NORTHEAST MAINTENANCE SUBSTATION ADDITION TO WICHITA, SEDGWICK COUNTY, KANSAS

RE: S/D- 98-93 - Final Plat of NORTHEAST MAINTENANCE SUBSTATION ADDITION

STAFF REPORT
(One-Step Final Plat)

CASE NUMBER: S/D 98-93 - NORTHEAST MAINTENANCE SUBSTATION
ADDITION

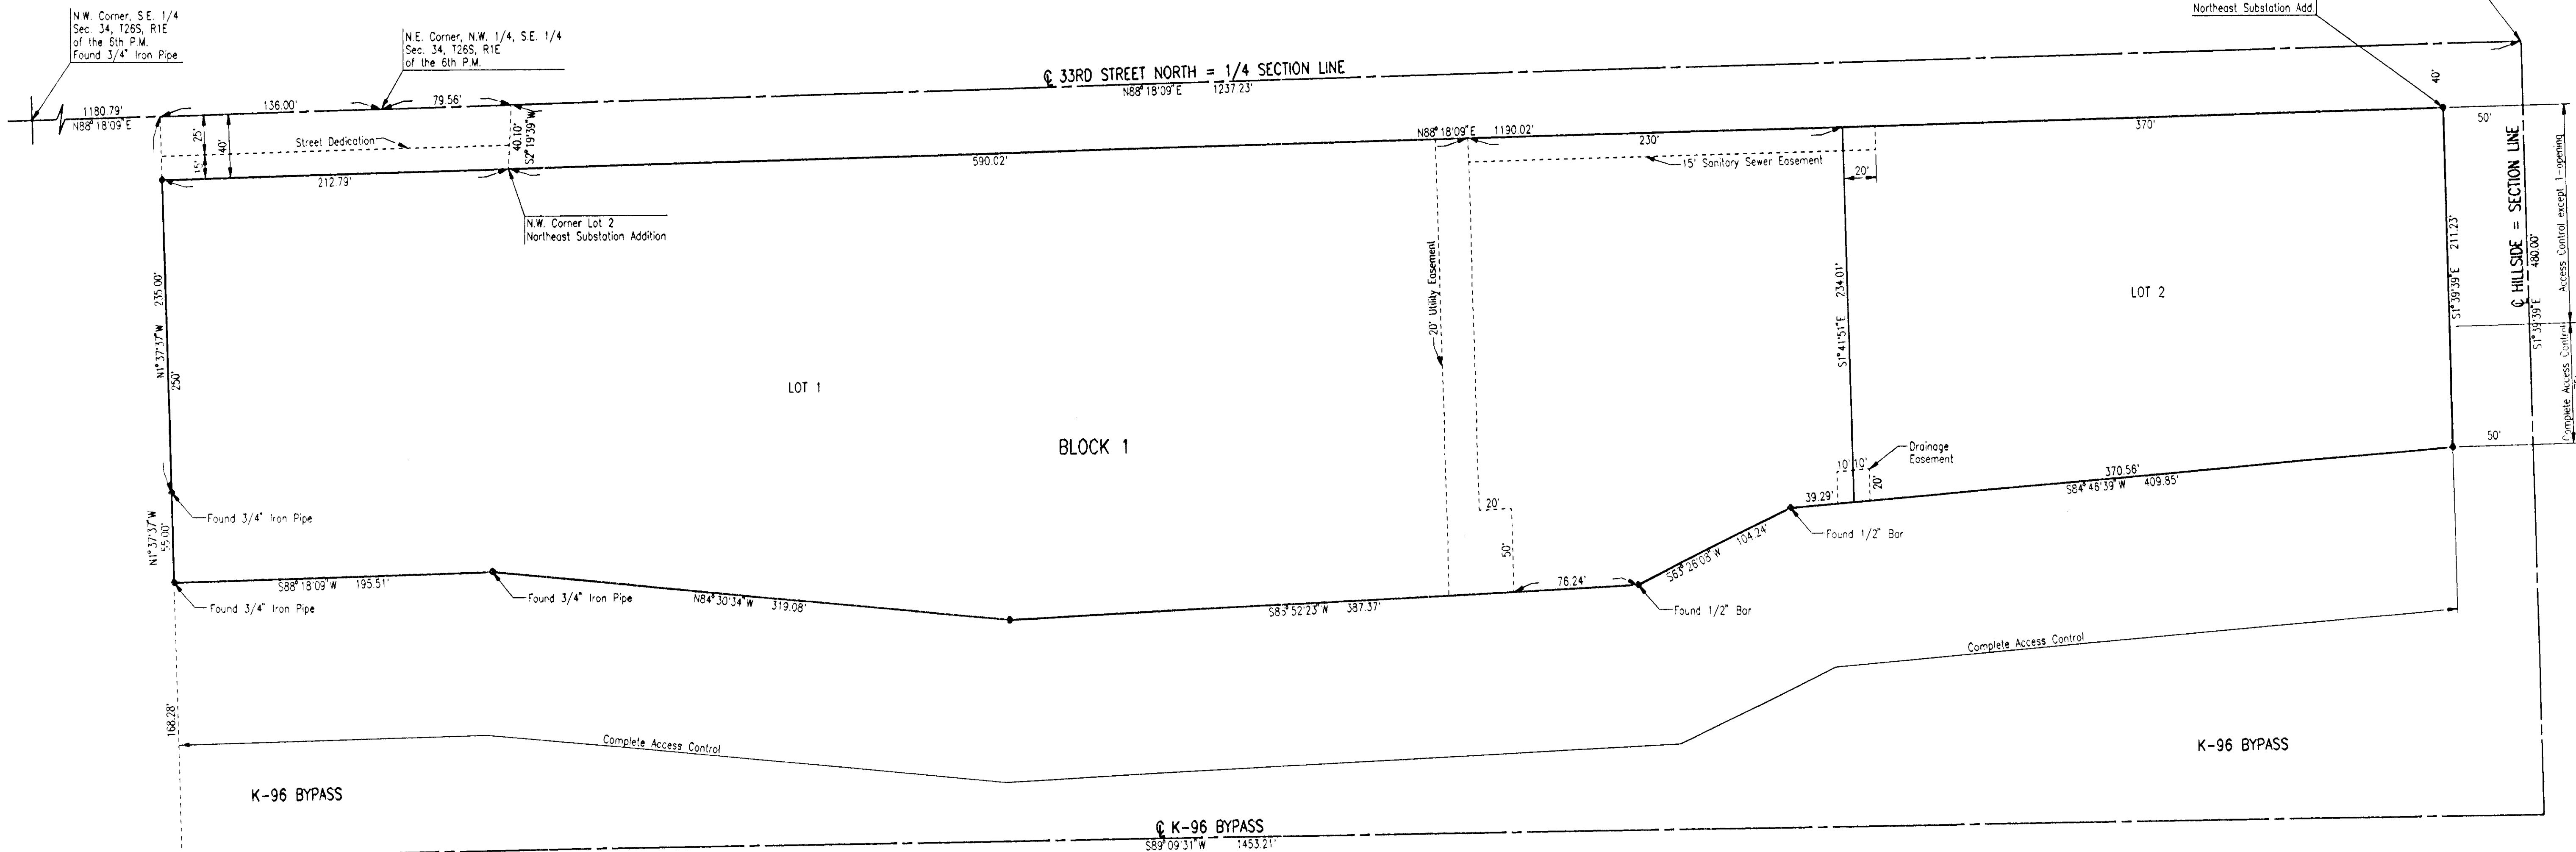
- A. Existing municipal services appear to be available to serve this site. City Engineering needs to verify if any other additional guarantees are required. *A guarantee needs to be provided for sanitary sewer extension to Lot 2.*

- C. City Engineering needs to comment on the status of the applicant's drainage plan. *A cross-lot drainage agreement needs to be established by separate instrument.*

- D. Traffic Engineering needs to comment on the platted access controls. The plat denotes one access opening along Hillside. Access controls dedicated along K-96 need to be referenced on the final tracing.

- E. Since drainage occurs onto K-96, a letter shall be provided from KDOT indicating their agreement to accept such drainage.
- F. The dedication of right-of-way for 33rd St. North needs to be referenced in the plat's text.

- G. This property is within a zone identified by the City Engineers' office as likely to have groundwater at some or all times within 10 feet of the ground surface elevation. Building with specially engineered foundations or with the lowest floor opening above groundwater is recommended, and owners seeking building permits on this property will be similarly advised. More detailed information on recorded groundwater elevations in the vicinity of this property is available in the City Engineers' office.

- H. Traffic Engineering needs to comment on the need for improvements to Hillside.
- I. The applicant shall install or guarantee the installation of all utilities and facilities which are applicable and described in Article 8 of the MAPC Subdivision Regulations. (Water service and fire hydrants required by Article 8 for fire protection shall be as per the direction and approval of the Chief of the Fire Department.)

- N. Perimeter closure computations shall be submitted with the final plat tracing.
- O. Recording of the plat within thirty (30) days after approval by the City Council and/or County Commission.

- P. The representatives from the utility companies should be prepared to comment on the need for any additional utility easements to be platted on this property.
- Q. The applicant is reminded that a disk shall be submitted with the final plat tracing to the Planning Department detailing this plat. This will be used by the City and County GIS Department.
